**RE: RM210147 Otaihanga Estates Subdivision
48 & 58 Tieko Street; 131, 139 & 147 Otaihanga Road, Paraparaumu
Geotechnical peer review**

Project Number: **MINZ210505.00**

Fig 1. Extract from Cuttriss plan (scale as shown) showing the location CPT1

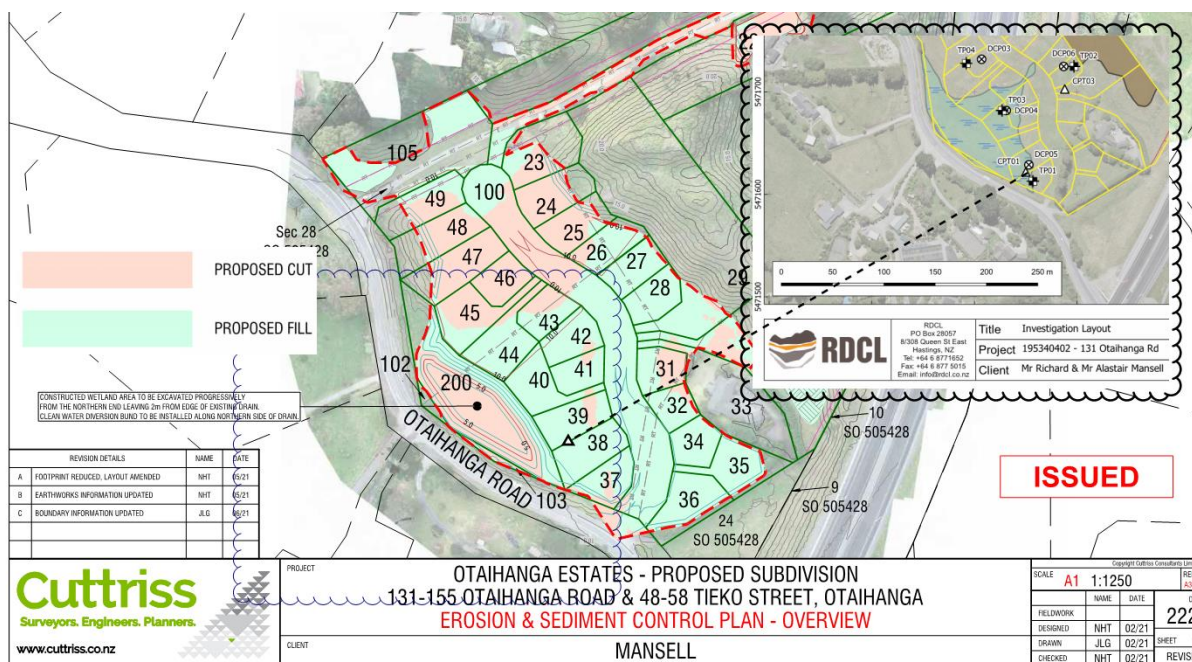
- We agree with the presented liquefaction triggering analysis, however depending on the ground water level (hence why inclusion of R.L. considered necessary), liquefaction triggering is likely within the top 2.0 to 3.0m along the transition layer before getting into the medium dense or dense sands. The location of the lower elevation CPTs, such as CPT 1 as shown below with a cut and fill for the construction of the required fill and a wetland, should be carefully considered for the slope stability of the final development under static, and more importantly, under seismic and post-seismic conditions.

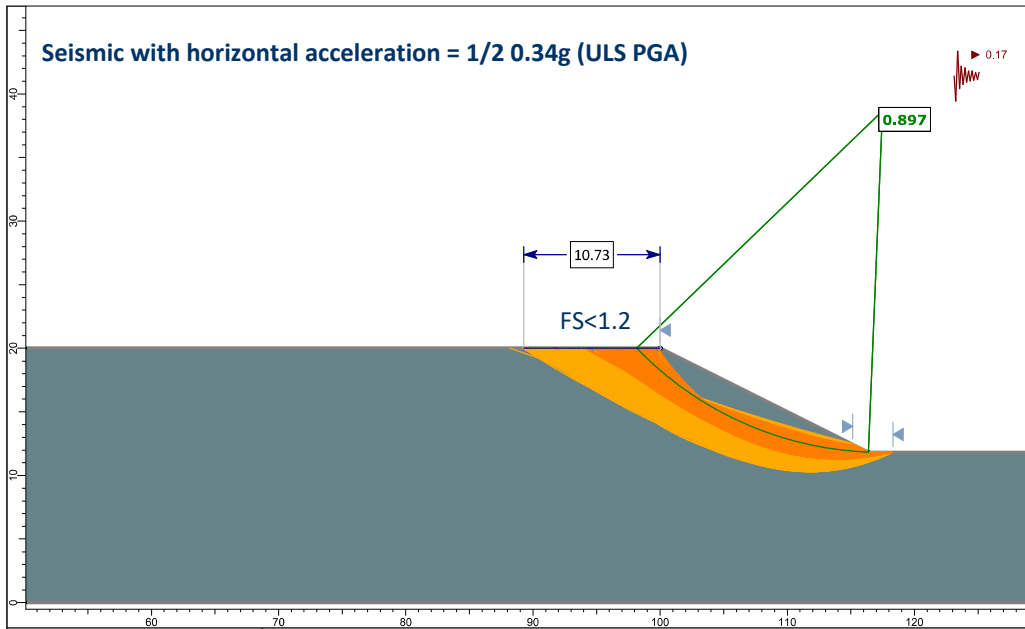
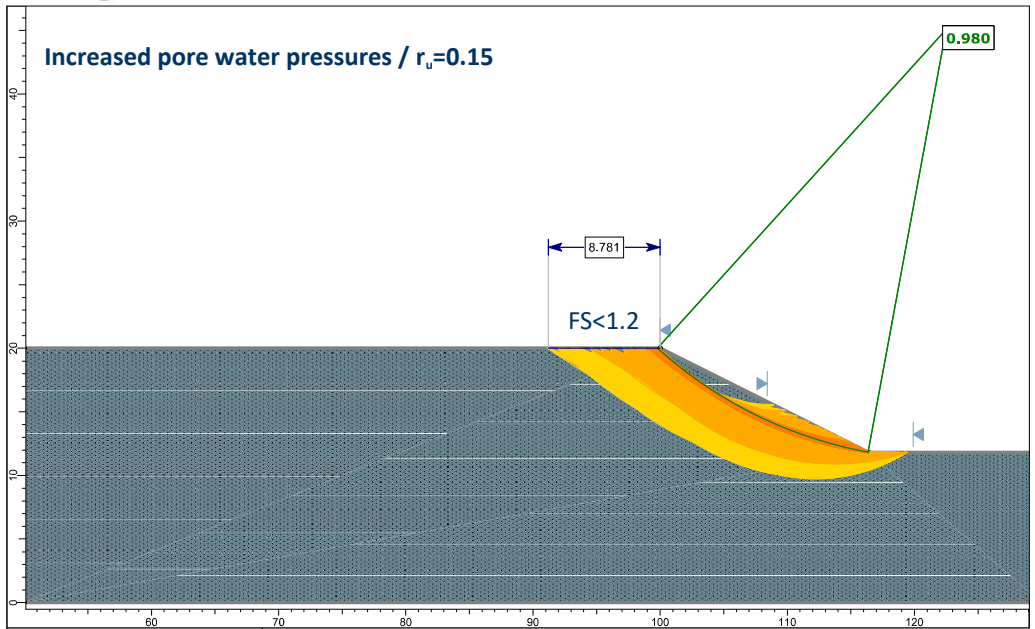
We are not certain how the proposed 3.0m setback derived, or how they were revised from 5.0 to 3.0m, hence our proposed need to clarify and supported with slope stability analysis capturing future loading conditions. Miyamoto's preliminary stability checks using the proposed slopes and Table 5 effective strength parameters cannot justify the given setback under the investigated loading conditions (i.e. static, seismic and increased pore water pressure using an r_u value of 0.15) for a loose silty sand slope, and a denser slope. A yield or critical acceleration value k_y of 0.119 and 0.204g identified for the examined slopes.
